From: Kresl, Zachary (FHWA) <zach.kresl@dot.gov>
Sent: Wednesday, March 3, 2021 1:02 PM
To: Smith, Jacob; Maiefski, Melissa; Petracek, Sue; pjinfne@dot.gov
Cc: Barber, Jon; Pitts, Luke
Subject: RE: For Your Review: Plan Revision R-1 Reevaluation, 21209, Murray - Plattsmouth

Subj: Project No. NH-75-2(128), C.N. 21209, Murray – Plattsmouth
Plan Revision R-1

Revised Sheets:	A2
Deleted Sheet:	B6
Added Sheets:	B6A, N13, N14

THIS SET OF PLANS IS
DRAFT PLAN REVISION 1

PROJECT NO. 75-2(128)	SHEET NO. B6A
C.N. 21209

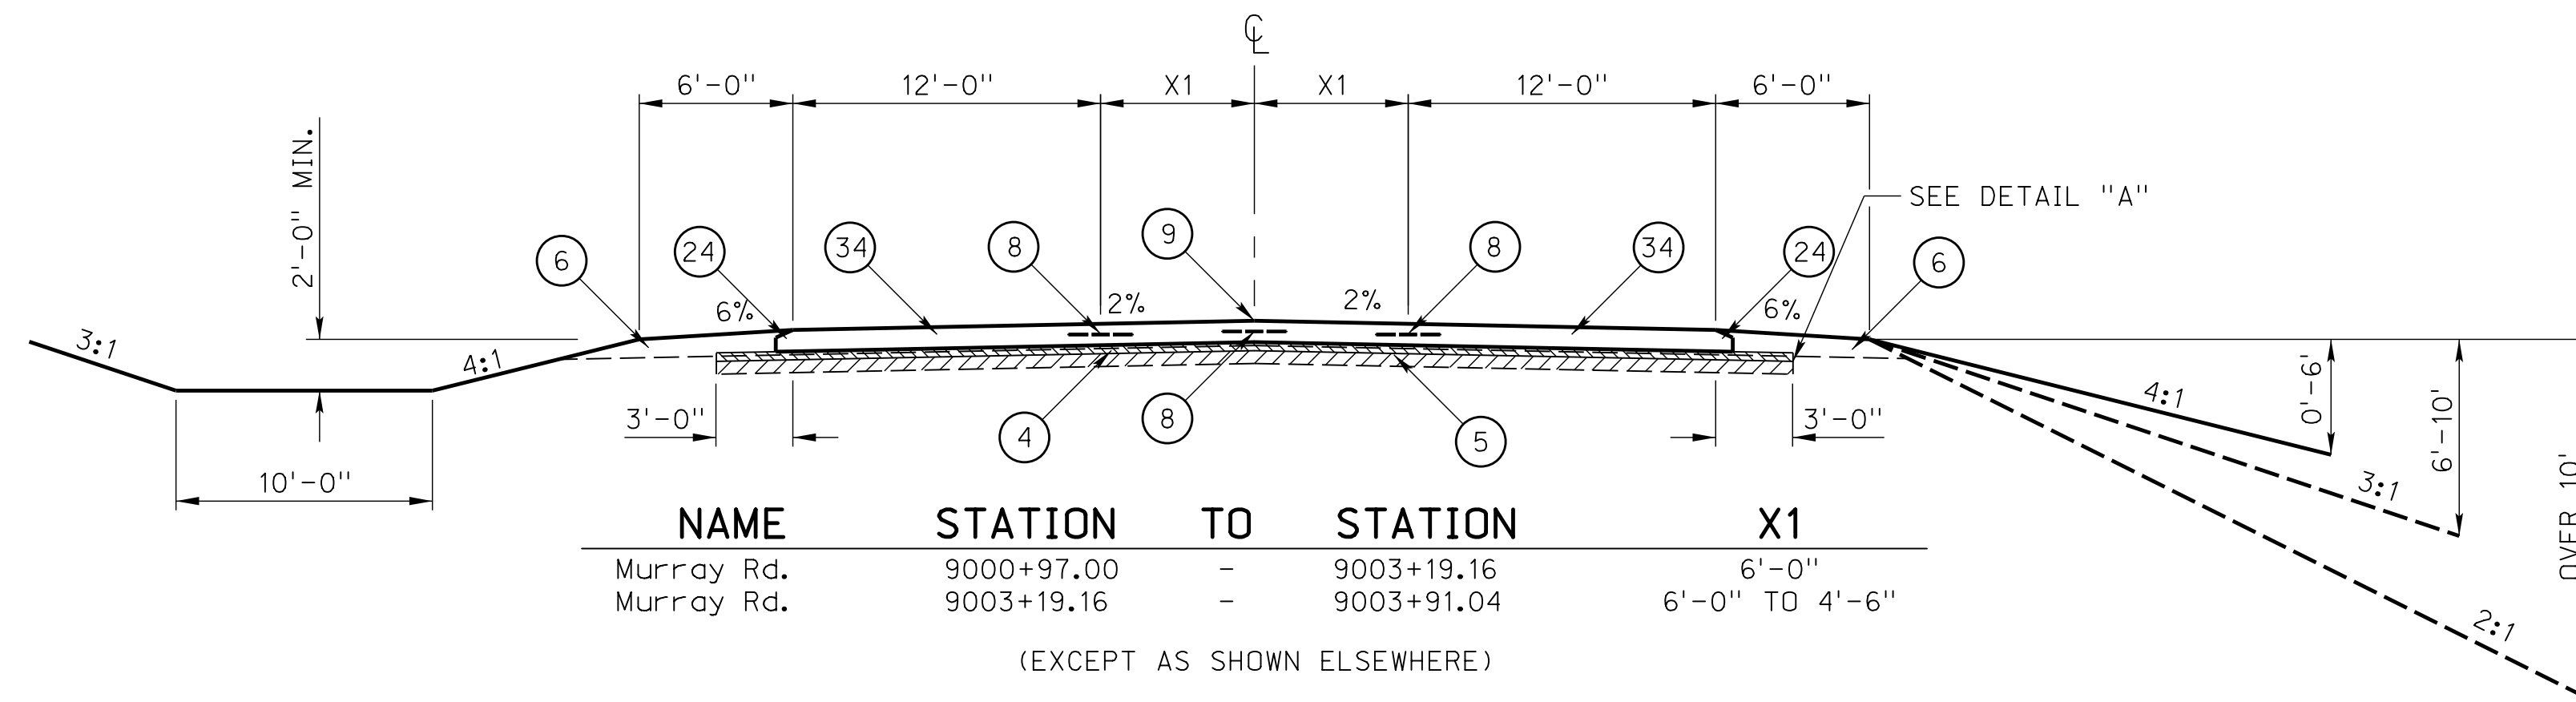
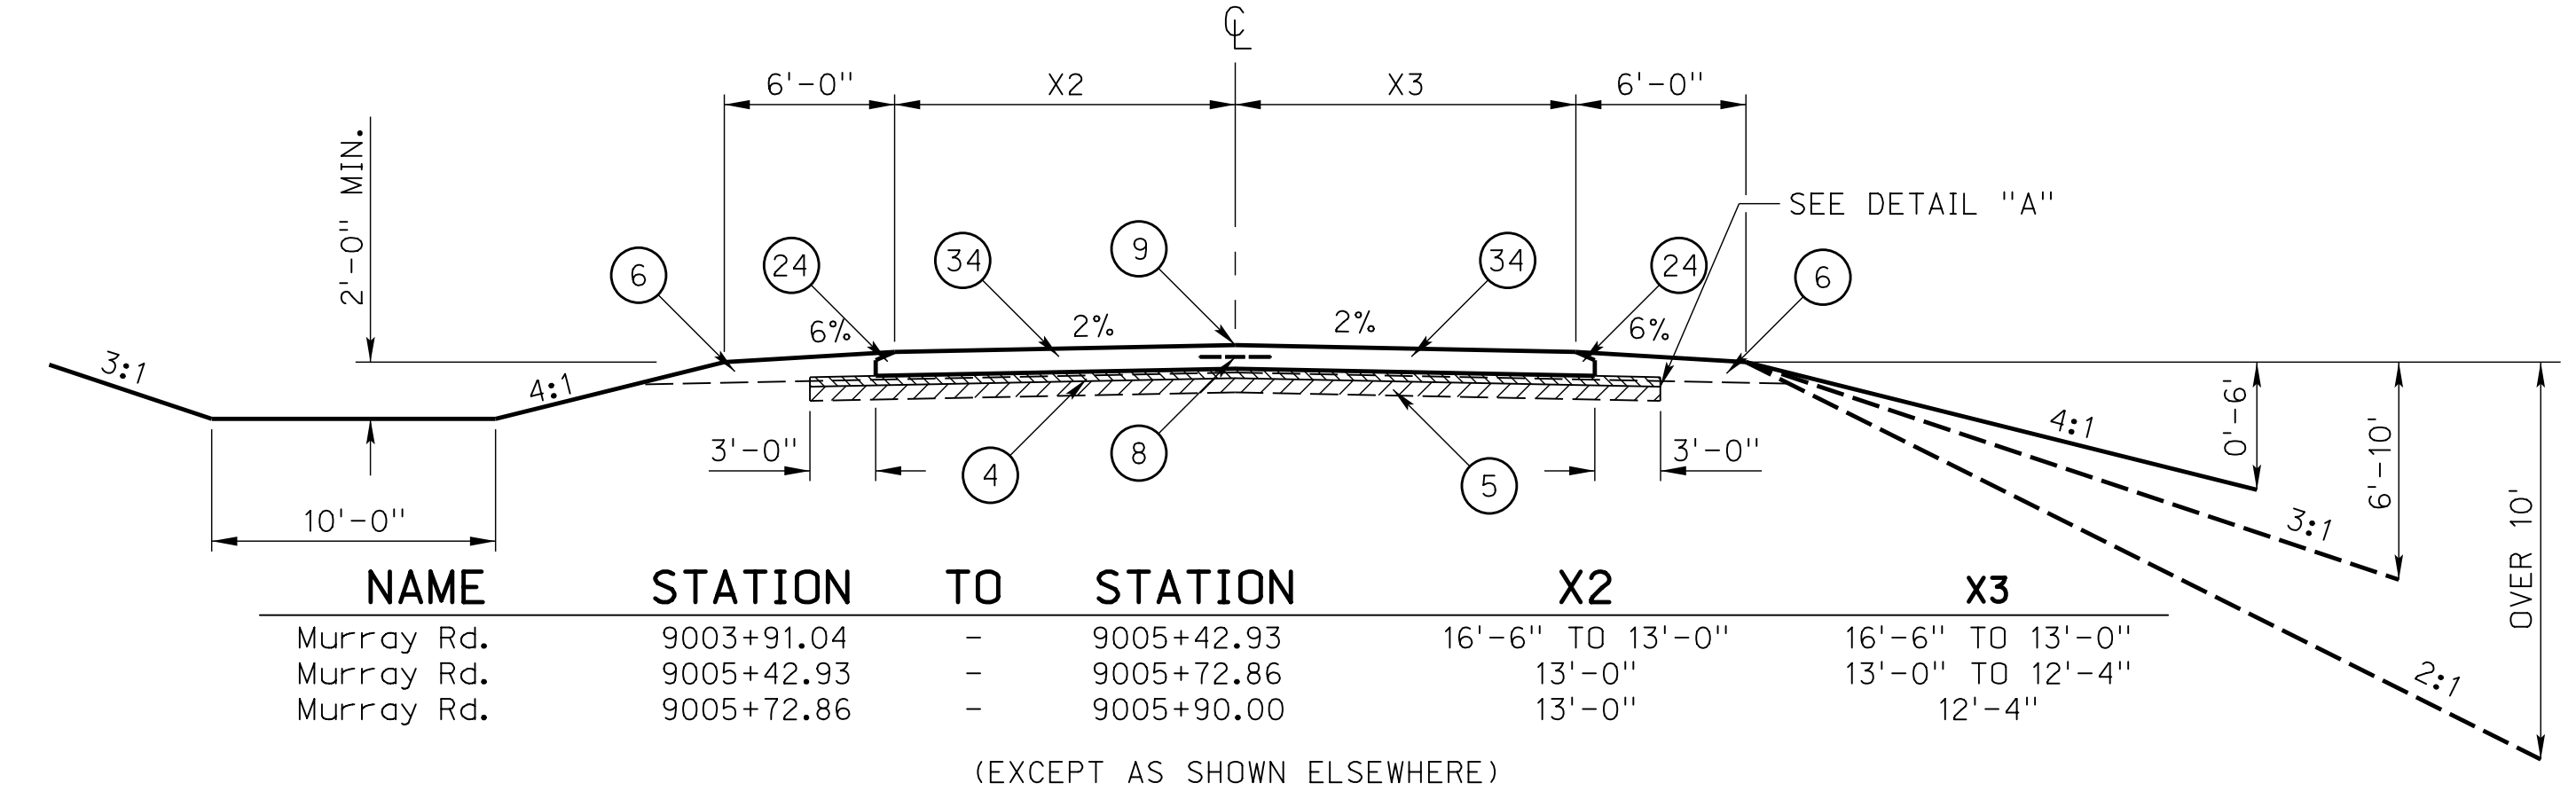
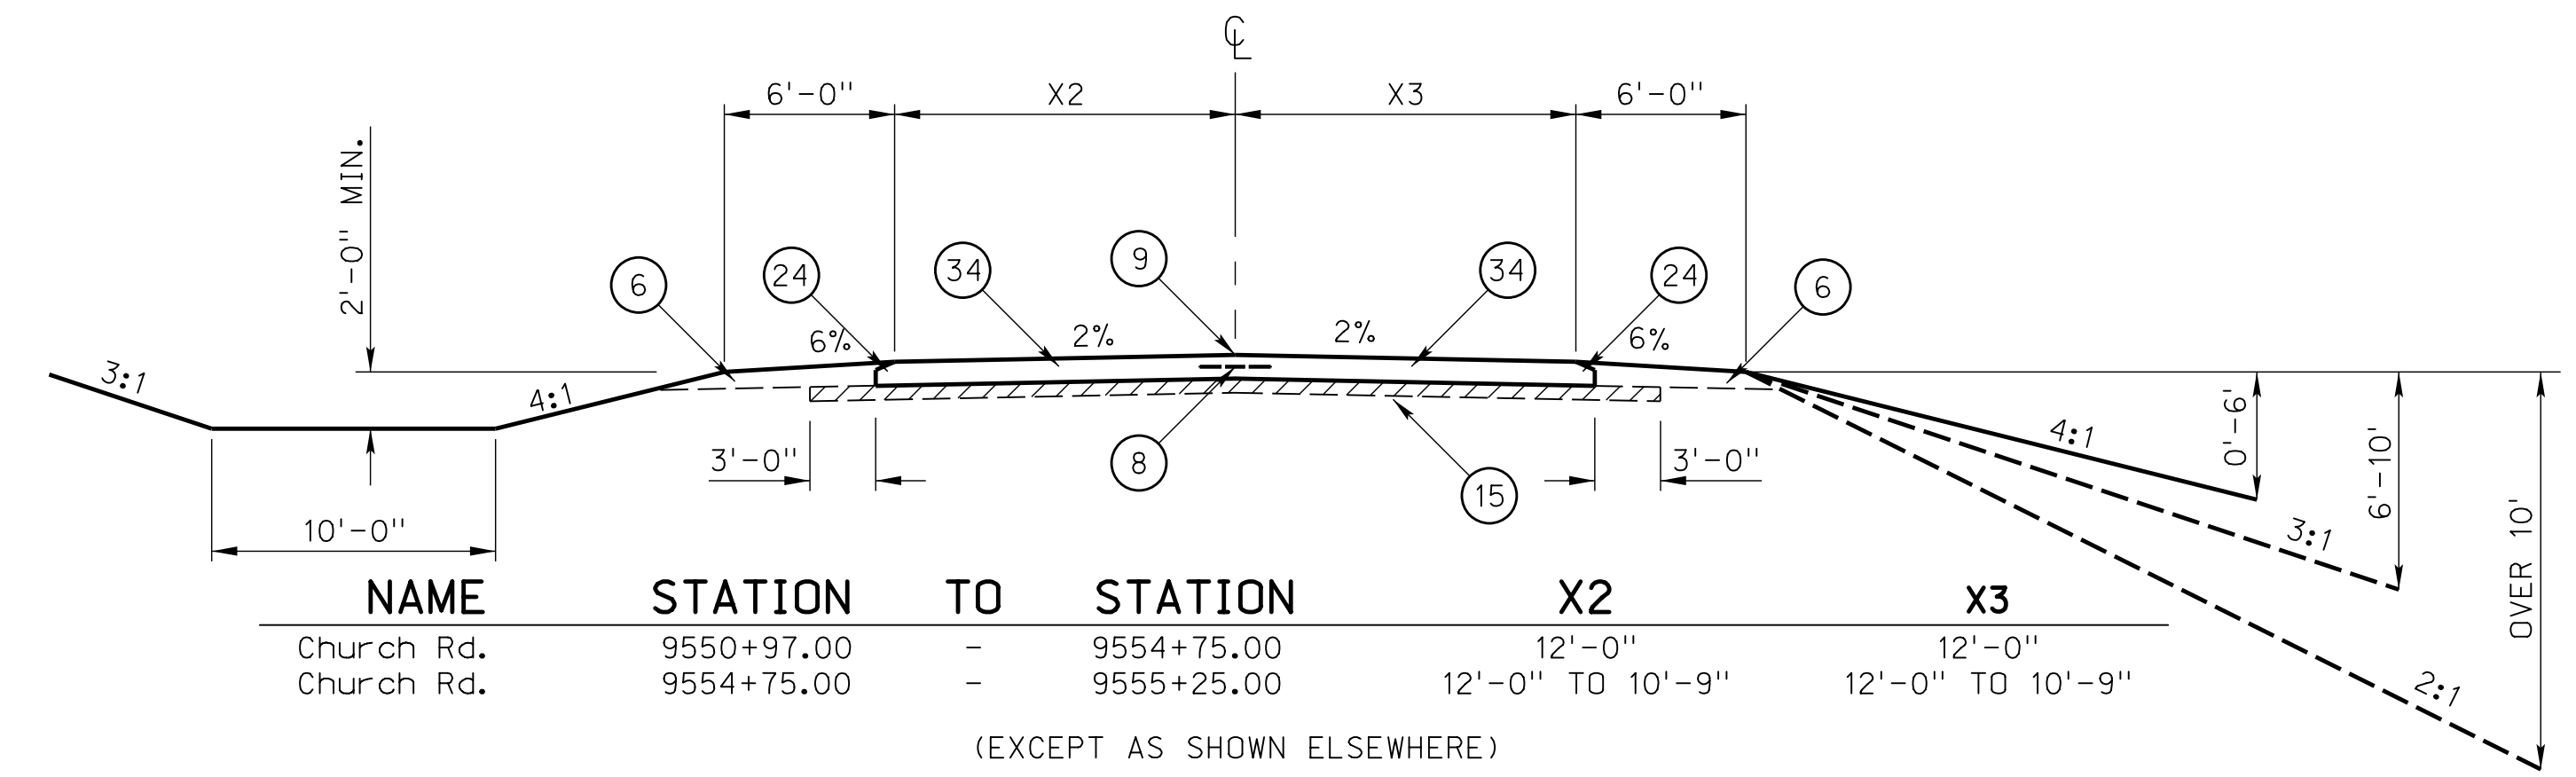
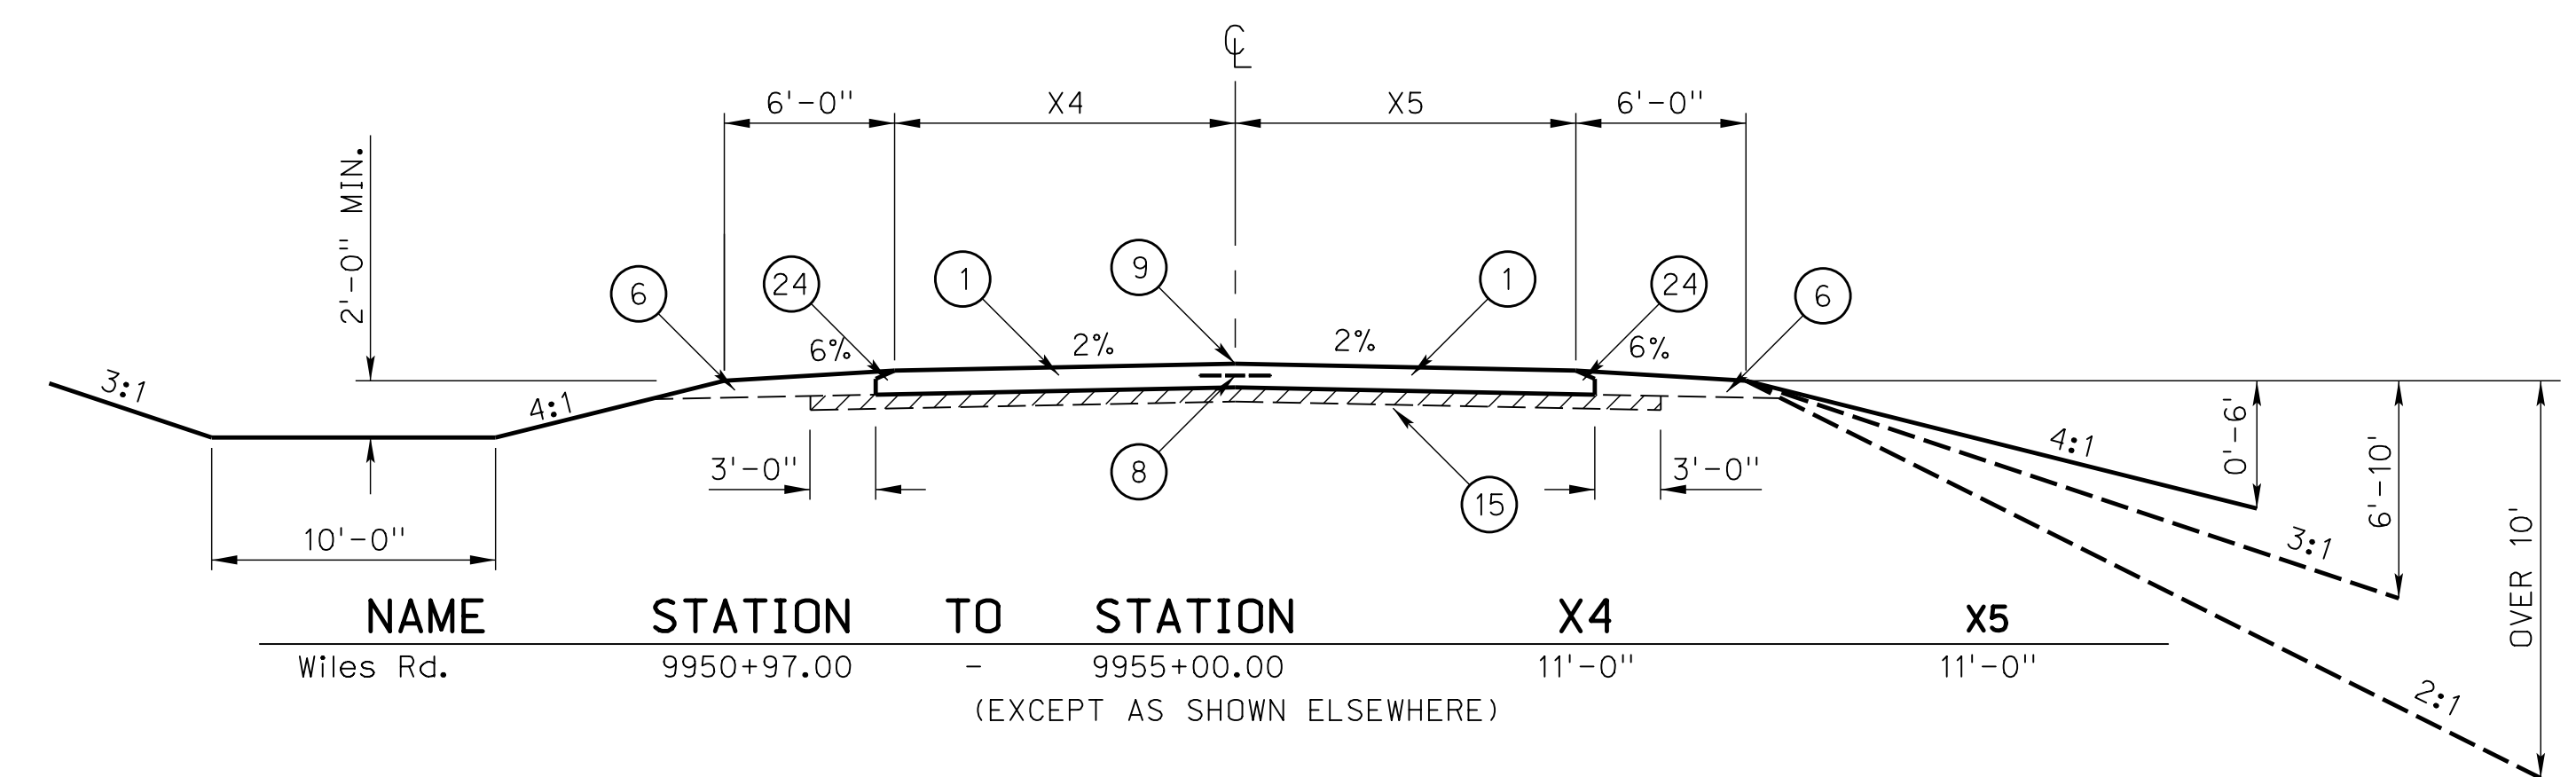
- Sheet B6 was deleted and sheet B6A was added to accommodate various typical changes:
 - The line titled “Rock Bluff Rd.” for station range “9201+42.00 – 9201+54.00” is void and has been removed per Addendum 1.

- In response to a contractor question in the letting process and confirmed by Roadway Design, the third typical on sheet B6, the number 2 bubble for 10” Concrete Pavement, has been changed to a number 1 for 10” Doweled Concrete Pavement.

- To coordinate with M&R pavement quantities that were provided in the letting plans, Foundation Course was added to Murray Rd. as well as Stabilized Subgrade, Type Lime. A new typical was created for Church Rd. since its base structure is only Subgrade Preparation and no Foundation Course. The line titled “Horning Rd.” for station range “9801+17.74 – 9801+49.00” is void and has been removed. Roadway Design, M&R, and Construction are in agreement with these changes.

**LED UNDERDECK LUMINAIRE SYSTEM
FOR BRIDGE STRUCTURE S034 37969**

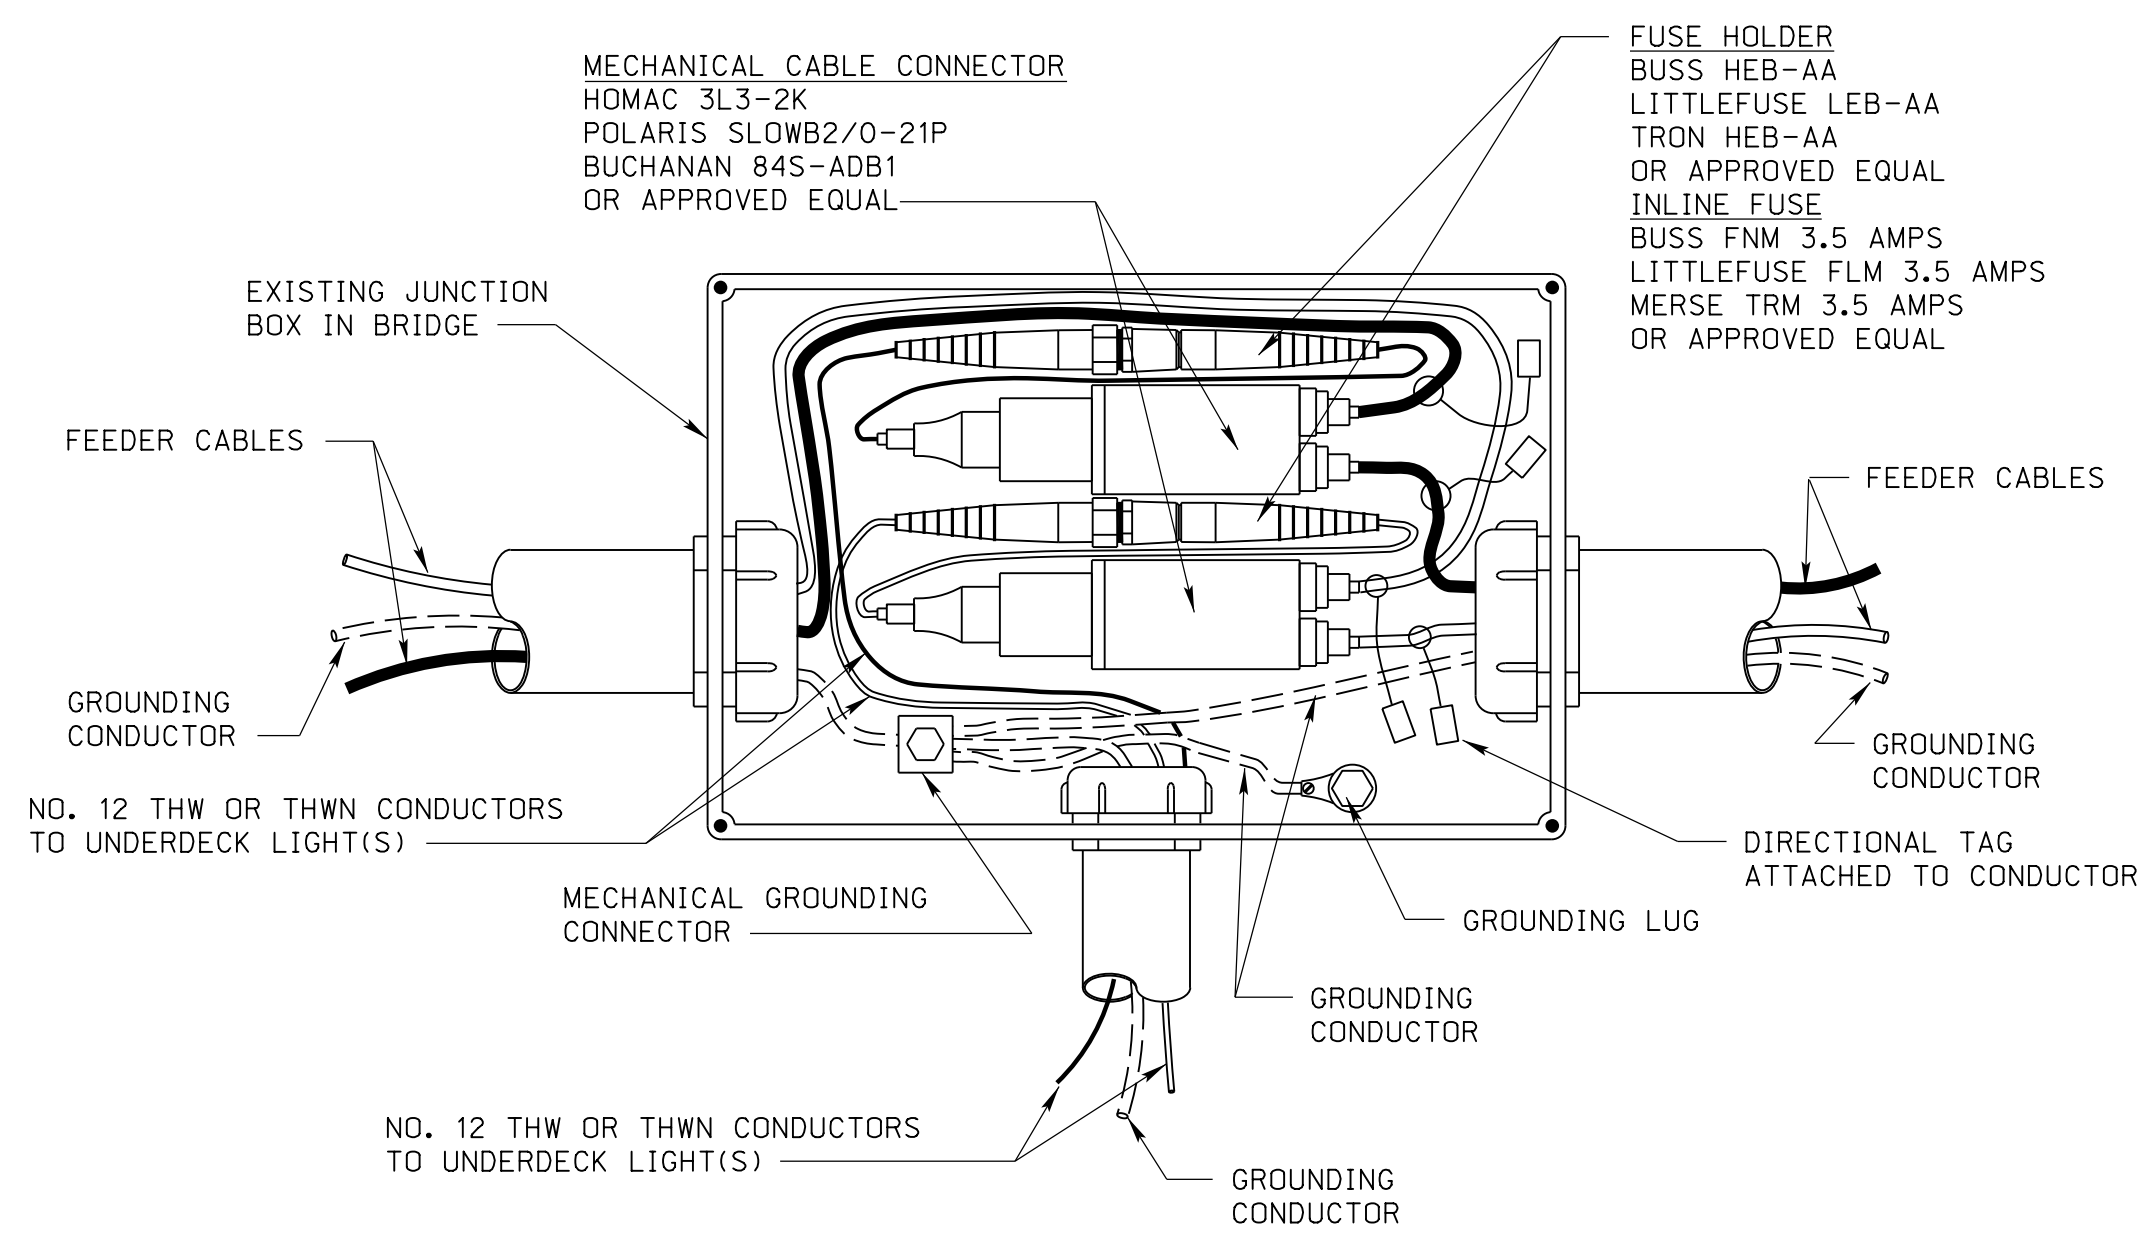
- Sheets N13 and N14 were added to show lighting details for the underdeck bridge lighting for structure #S034 37969 over the UPRR.
